Board of Zoning and Planning Staff Report – July 25, 2019

Application No.: BZAP-19-10
Applicant: Brent Foley – Triad Architects
Owner: St. Charles Preparatory School
Location: 2010 E. Broad Street

BZAP Request: The applicant is seeking review and approval of a parking lot expansion and landscaping, on the east side of the St Charles Preparatory School, in accordance with Bexley Code Section 1254.07 (OS) Open Space Zoning District.

St Charles aerial view North of Broad St.

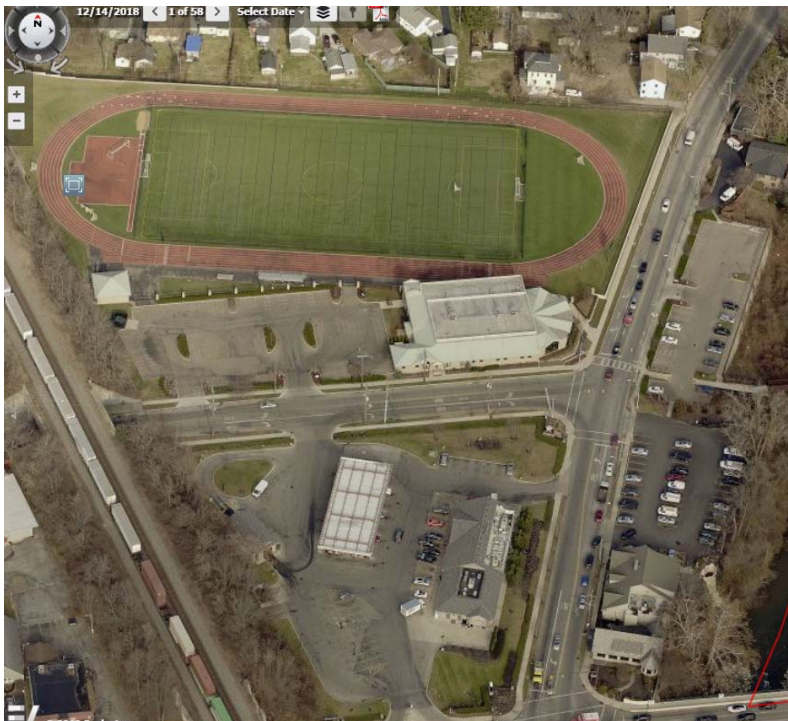
The existing parking lot on-site at St. Charles has 272 parking spaces.

The 71 spaces proposed only help with the code required parking. It does not encroach any further into the front yard of the campus than other park/drive areas and will have screening similar to what exists in front of the west lot on campus. There are existing trees that provide some screening along the east side property line, bordering Meadow Park Drive. The plan provides additional evergreen to border the east edge of the existing and proposed lots on the east. It is recommended that the Tree & Public Garden Commission review landscaping in order to ensure screening from adjacent property

The east lot is currently only accessible from the tunnel which runs through the school building. The proposed improvements will allow access from the main entrance drive off of Broad Street. It further will allow fire truck access to the east side of the building, as a fire truck would not fit through the existing tunnel.

The parking requirements are not yet met; however, St. Charles obtained property outside of Bexley to assist with their parking needs prior to simply expanding parking on their existing campus site in Bexley. Additional parking can only help the function of the school facility and will provide a total of 453 parking spaces between the two properties. Staff supports the additional parking in the proposed location, with landscape screening review subject to the approval of Tree & Public Garden Commission or their designee.
